PREVOST

**WARRANTY
BULLETIN**

WB17-02A

DATE :	April 2017	SECTION :	23 ACCESSORIES
EXPIRATION:	April 2019		
SUBJECT :	ADDITION OF AN EXTENSION TO THE LINEAR THERMAL DETECTOR (LTD)

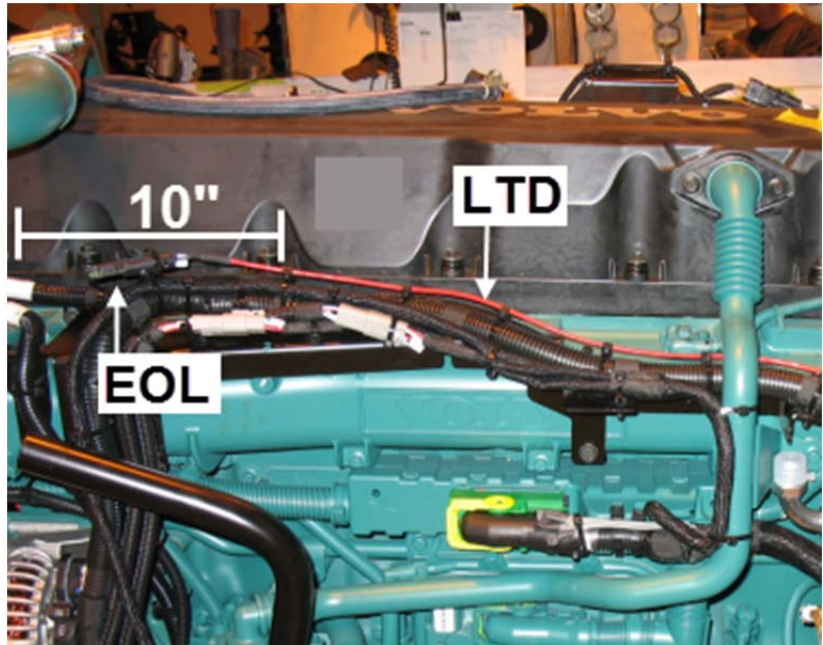
- 1) On the cold side of the engine, remove the End of Line (EOL) resistor from the existing LTD connector. **Keep the EOL resistor for reuse.**

NOTE: position of the EOL resistance may vary from about 10 inches from one vehicle to another. This position will determine the final position of the EOL resistor once connected at the end of the extension.

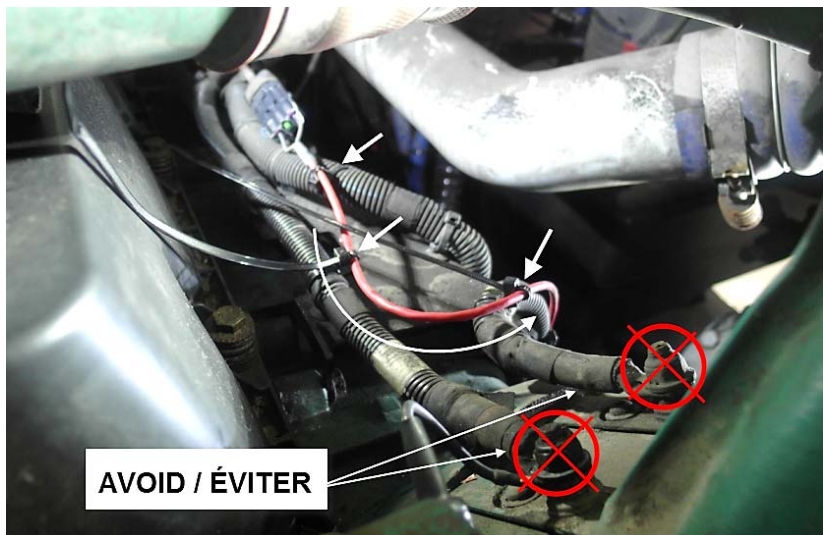
- 2) Plug extension #069175 to the LTD connector. Make sure that the connector remains properly secured with a nylon tie.

NOTE: The actual installation on your vehicle may vary depending on where the LTD connector is located.

NOTE: secure the extension with double loop cable ties at least every 4 inches. Follow the various guidelines highlighted in PART 1 of this bulletin.

NOTE: respect the 2 inches radii.

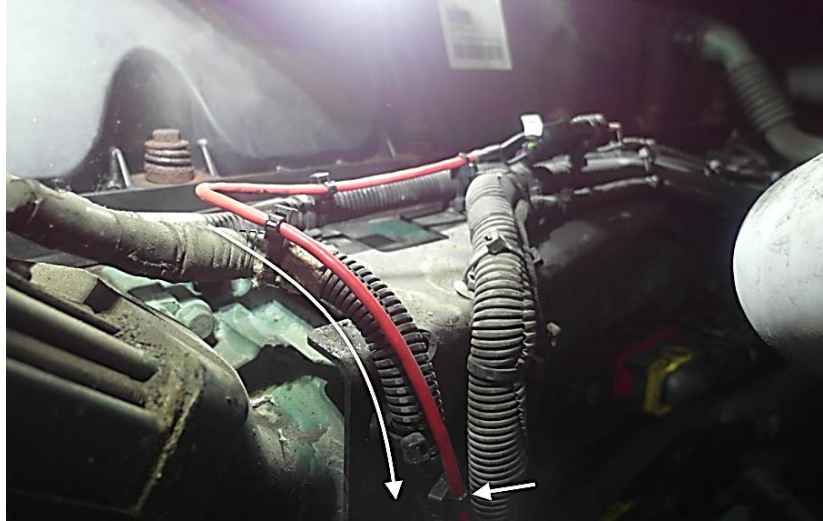
NOTE: short arrows indicate a nylon cable tie.

MAKE A CURVE WITH THE LTD AND THEN ROUTE IT DOWN ON THE PREHEATER GROUND CABLE (gnd-0B1-2). KEEP THE LTD CLEAR FROM THE PREHEATER STUDS.

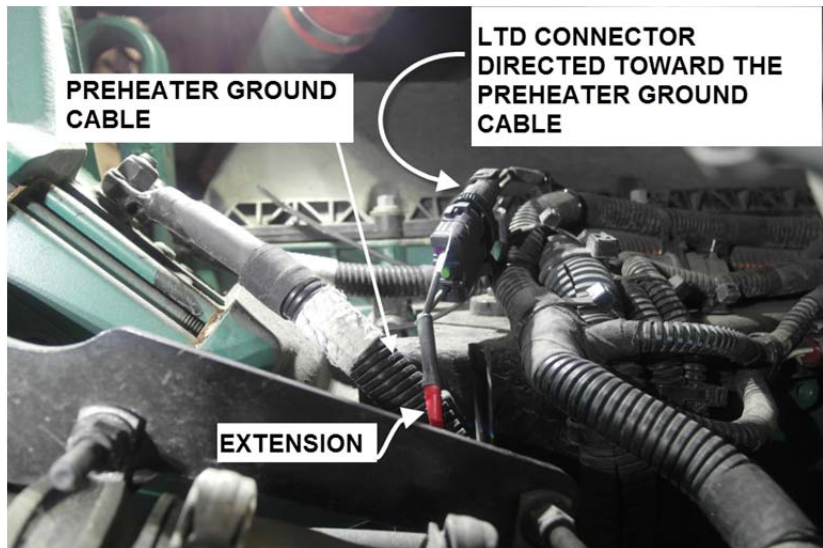
- 3) Route the LTD wire to a point forward of the upper alternator. The terminus point will vary from one vehicle to another.

- 4) Under the intake air preheater.

- 5) Plug the EOL resistor at the end of the extension.

NOTE: extension connector must be properly secure with a nylon tie.

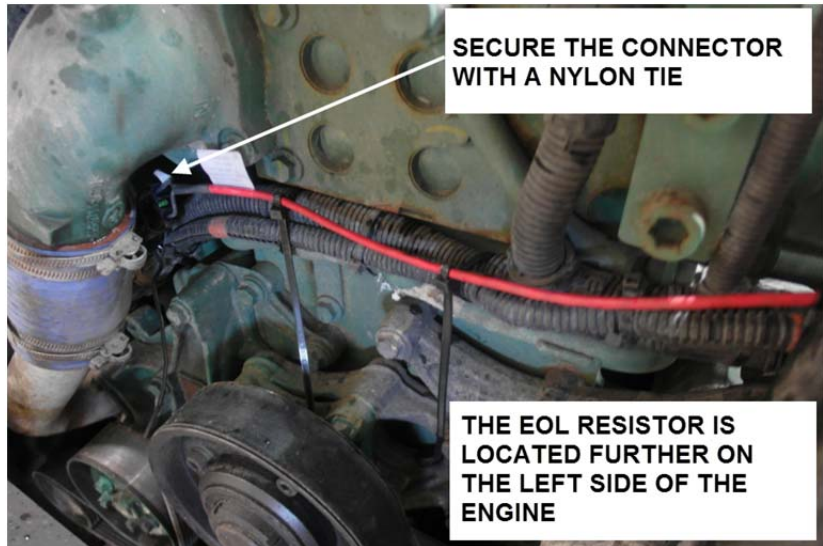
- 1) The LTD connector is located near the intake air preheater; it is therefore directed toward the descending section of the ground cable. Keep the extension clear from the preheater studs.

NOTE: the connector must be securely attached using a nylon tie.

- 2) Consequently, the EOL resistor is located farther on the left side of the engine.

NOTE: The connector must be securely attached using a nylon tie.
